Access Compliance Report

Public Rights-of-Way

Intersection ID: N/A	Main Street: E MARTIN LUTHER KING JR BV	Cross Street: S CALDWELL ST	Location: E
ADA ID: F55CE8CA15B7	Ramp Type: PerpDiag	Initial Pass/Fail: Fail	Overall Compliance: No
Severity Score: 33.75			
Codes/Mitigation Info/Possible Solution		Field Measurements/Component Compliance

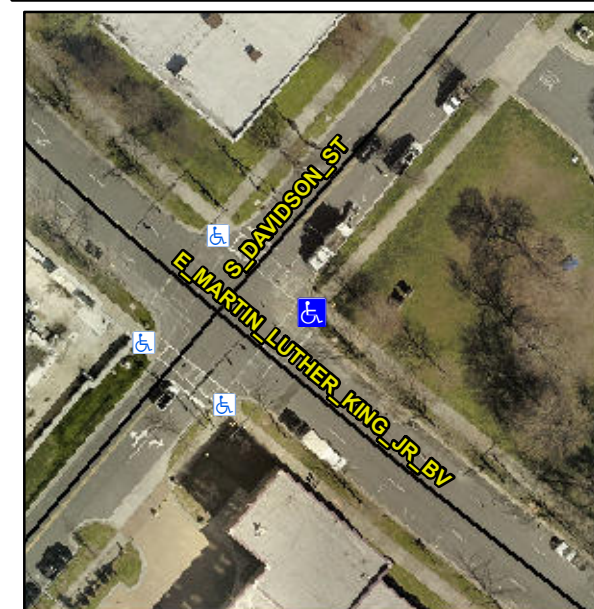
Not Found, R304.5.1, R304.2.2

Compliance	Description	Data	Compliance	Description	Data
N/A	Ramp Length (in)	102.0	No	Ramp Slope (%)	12.1
No	Ramp Width (in)	39.0	Yes	Ramp XSlope (%)	1.3
N/A	Flare Type LT	N/A	N/A	Flare Type RT	N/A
N/A	Flare Slope LT (%)	N/A	N/A	Flare Slope RT (%)	N/A
N/A	Flare Traversable LT?	No	N/A	Flare Traversable RT?	No
N/A	Landing Length (in)	N/A	N/A	DWS Provided?	N/A
N/A	Landing Width (in)	N/A	N/A	DWS Contrast?	N/A
N/A	Landing Slope (%)	N/A	N/A	DWS Length (in)	N/A
N/A	Landing X Slope (%)	N/A	N/A	DWS Full Width?	N/A
N/A	Landing Curb? (Y/N)	N/A	N/A	DWS Offset (in)	N/A
N/A	Shared Landing?	N/A			
N/A	Gutter Ponding?	N/A	N/A	Gutter Slope (%)	N/A
N/A	Gutter Lip Ht (in)	N/A	N/A	Gutter X Slope (%)	N/A
N/A	Painted X Walk1?	Yes	N/A	Painted X Walk2?	Yes
	X Walk 1 Direction	To NW		X Walk 2 Direction	To SW
N/A	X Walk 1 Width (in)	110.0	N/A	X Walk 2 Width (in)	115.5
	X Walk 1 Slope (%)	0.9		X Walk 2 Slope (%)	0.8
	X Walk 1 X Slope (%)	0.4		X Walk 2 X Slope (%)	3.2

Remove & Replace Curb Ramp With Two New Directional Ramps or Equivalent.
